A303 Amesbury to Berwick Down (Stonehenge)

Wiltshire Council Response to Statutory Consultation

April 2018

Plan 1 – Western Section – Winterbourne Stoke Bypass to Longbarrow Roundabout

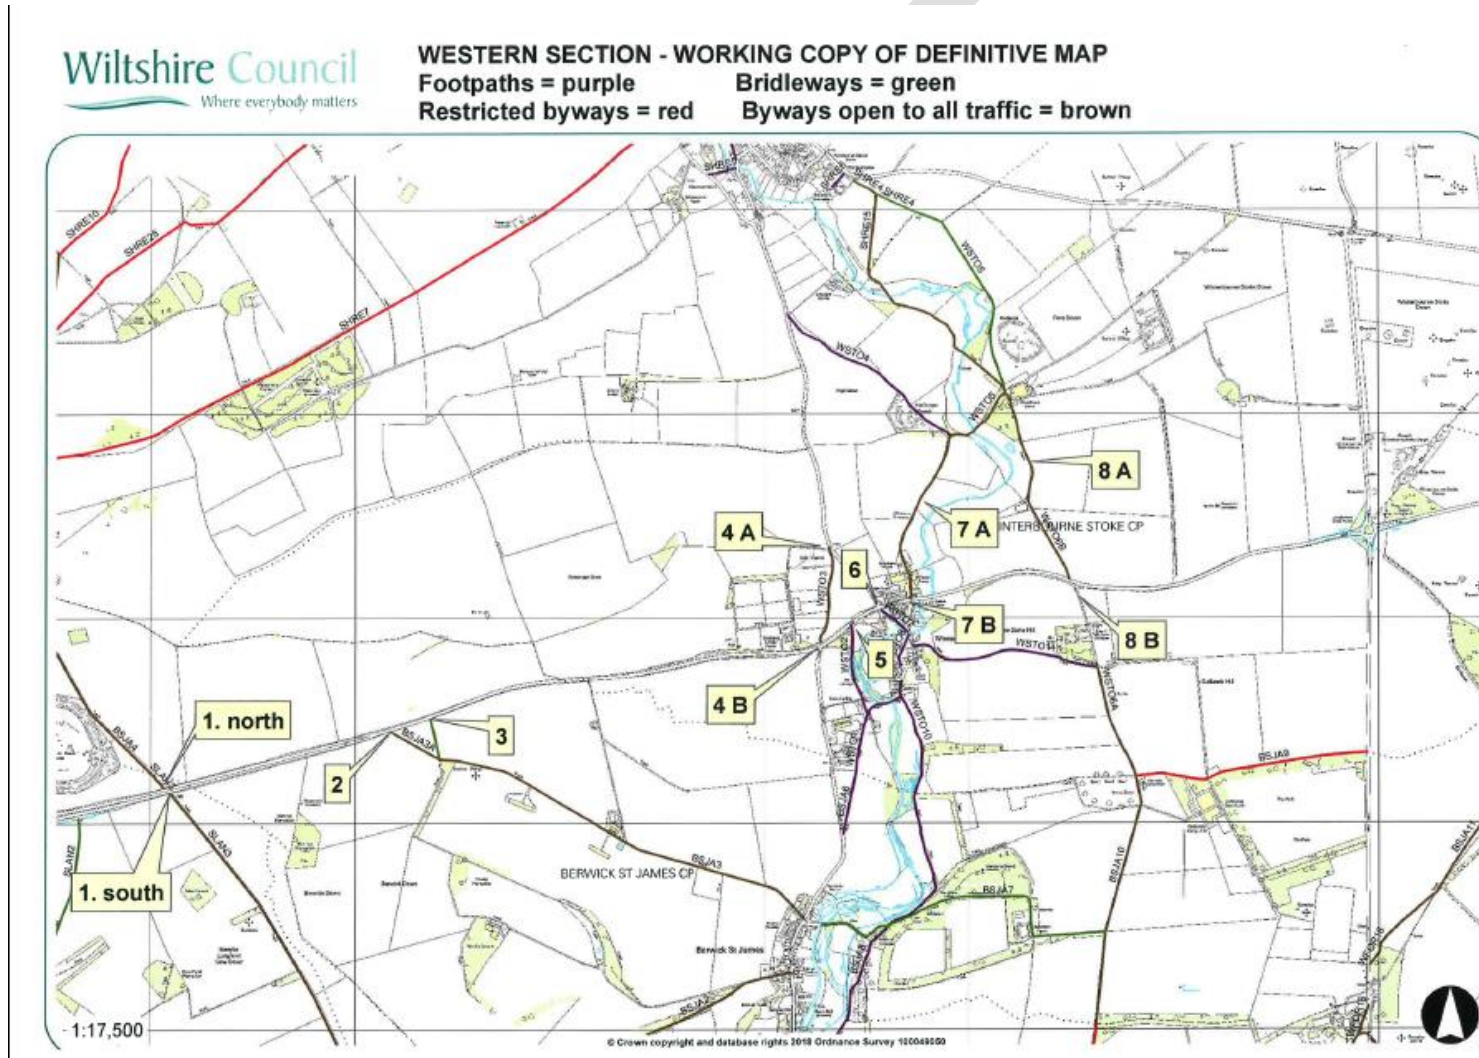
No. on Plan	PROW Number	Recorded Status	Interaction with Proposal	HE Proposal	Wiltshire Council Comments
1	SLAN 3	BOAT	Crosses A303	MPVs to use existing crossing. Status of new routes to be created on north and south of A303, linking to Green Bridge No. 1 and shown as “byway” is unclear	New routes need to be created as minimum of RB, but if created as BOAT then A303 crossing could be closed? Also see BSJA 3A and BSJA 3
2	BSJA 3A	BOAT	Meets A303	Missing from consultation plans	Needs to be stopped-up and BSJA 3 retained as BOAT. Unless direct access is to be retained from BSJA 3 onto A303, new route on south side of A303 needs to be BOAT to link to SLAN 3
3	BSJA 3	BW and BOAT	Meets A303	Appears to meet “Byway with private means of access” to Green Bridge No. 1 (Fig 5.4)	Needs to be BOAT to prevent cul-de-sac. If no direct access to be retained onto A303, new route on south side of A303 needs to be BOAT, to both west and east

4	WSTO 3	BOAT	Meets old A303	Proposed re-alignment of B3083 will affect northern end of WSTO 3	Small diversion proposed at northern end to meet re-alignment of B3083
5	WSTO 2	FP	Meets old A303	Old A303 to be downgraded to local road	No change
6	WSTO 7	FP	Meets old A303	Old A303 to be downgraded to local road	No change
7a	WSTO 5	BOAT	Crosses new A303	No mention – to pass under the River Till viaduct	Ensure sufficient headroom available
7b	WSTO 5	BOAT	Meets old A303	Old A303 to be downgraded to local road	Creates cul-de-sac BOAT
8a	WSTO 6B	BOAT	Meets new A303	Green Bridge No. 2 to carry “byway” across new A303	Preserve as BOAT
8b	WSTO 6B	BOAT	Over new A303 (Green Bridge No. 2) Meets old A303	Old A303 to be downgraded to local road

Plan 2 – Central Section – Including World Heritage Site

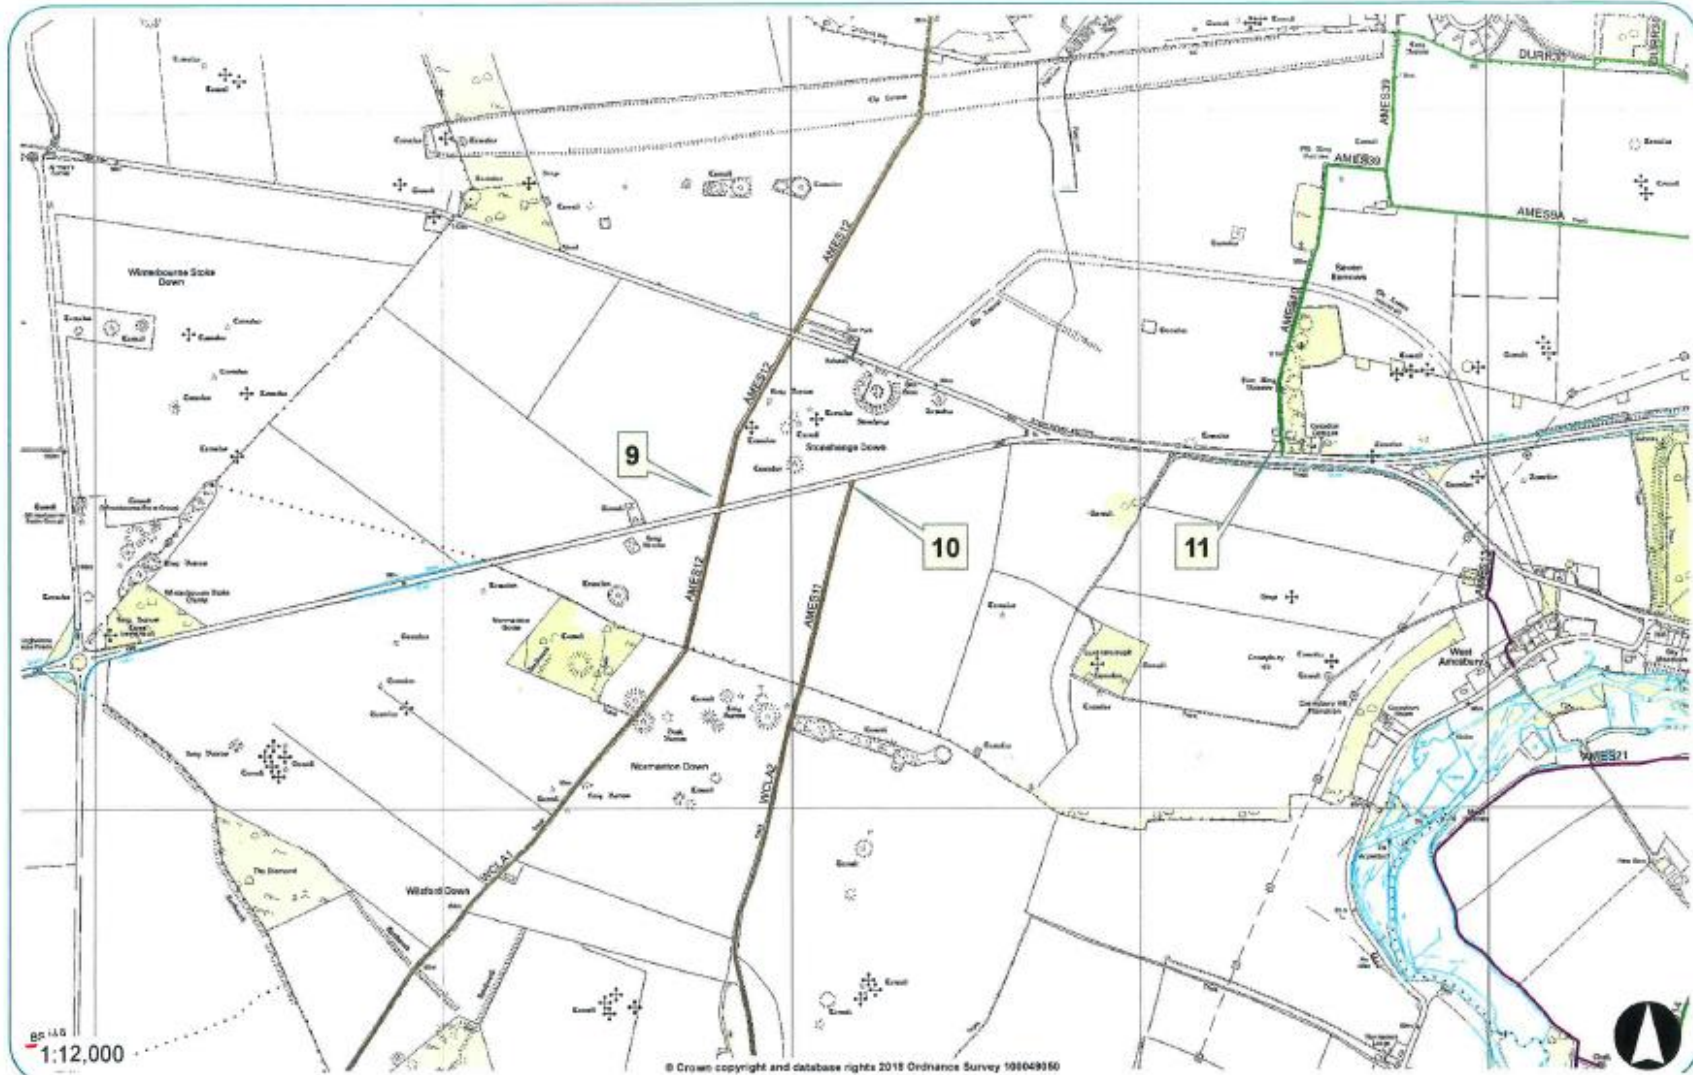
No. on Plan	PROW Number	Recorded Status	Interaction with Proposal	HE Proposal	Wiltshire Council Comments
9	AMES 12	BOAT	Crosses old A303	Old A303 vehicle rights to be extinguished but consultation states that Byway 12 will continue to lead north over the road. HE supports removal of MPV rights on 11 and 12. Retention of old A303 as private vehicular access between Longbarrow Roundabout and Old Stonehenge Road also proposed as "byway"	Highway Authority has Highways Act 1980 S.130 duty to prevent, as far as possible, the stopping-up of the highway. MPV rights (if retained) on BOAT would need to be preserved over the crossing point of old A303. Status of public rights to be retained on old A303 between Longbarrow Roundabout and Old Stonehenge Road should be RB
10	AMES 11	BOAT	Meets old A303	Old A303 vehicle rights to be extinguished. Byway to be diverted to join 12. HE supports removal of MPV rights on 11 and 12	Creates cul-de-sac BOAT. Highway Authority has Highways Act 1980 S.130 duty to prevent, as far as possible, the stopping-up of the highway. Diversion suggested is reasonable as access is possible north on BOAT 12, but proposed diversion route is known to not be supported by National Trust and Historic England, so an alternative solution is required (see recommendation made in paragraphs 89-101 above). If the balance of interests is such that Prohibition of Driving Orders are made to exclude mechanically propelled vehicles from BOATs 11 and 12, no new link between the two needs be created as all non mpv users will be able to use the on-surface track of the current A303 as long as that track is created as a RB.

Plan 3 – Eastern Section – Countess Junction to Solstice Park Junction

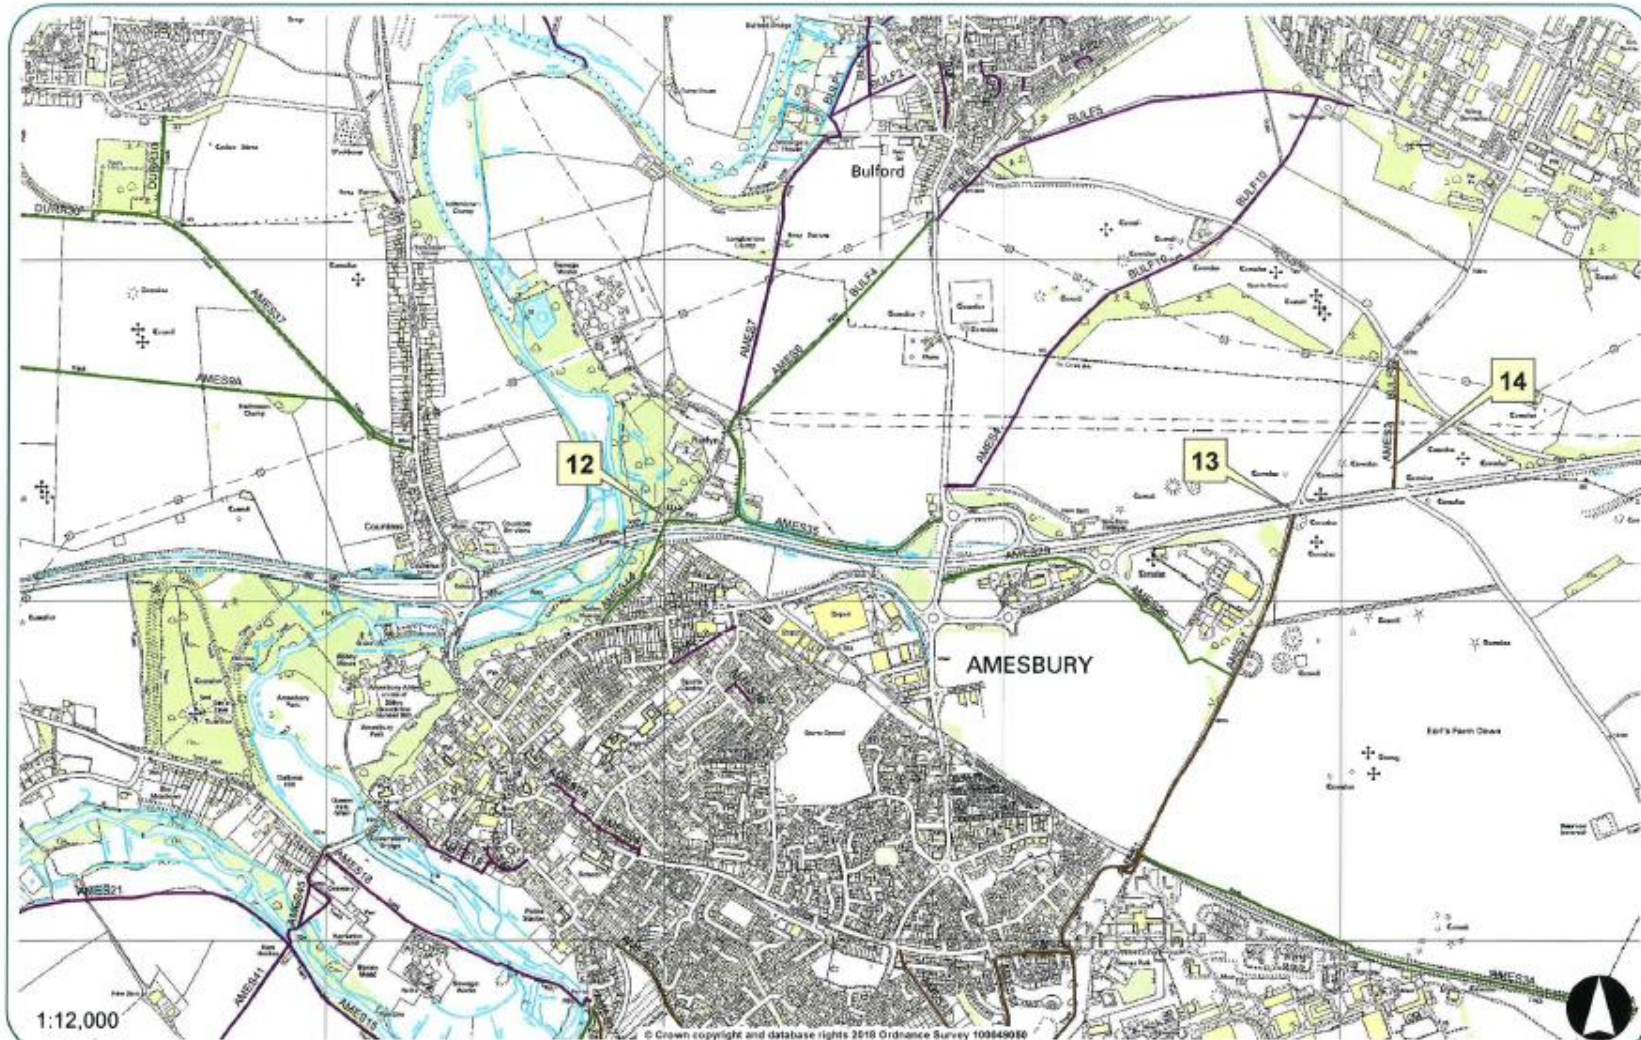
No. on Plan	PROW Number	Recorded Status	Interaction with Proposal	HE Proposal	Wiltshire Council Comments
12	AMES 44	BW	Cross A303 over bridge	Not mentioned	Bridge to be retained to maintain access
13	AMES 1	BOAT	Meets A303 south of A303	AMES 1 to be stopped up and connection A303 closed. New link between Allington Track and Amesbury Road created south of A303. AMES BW 29 is incorrectly shown as "byway"	Adequate provision to south. Look at alternatives for going north of A303
14	AMES 2	BOAT	Meets A303 north of A303	AMES 2 to be stopped up and connection to A303 closed	No provision north. No connection south of A303
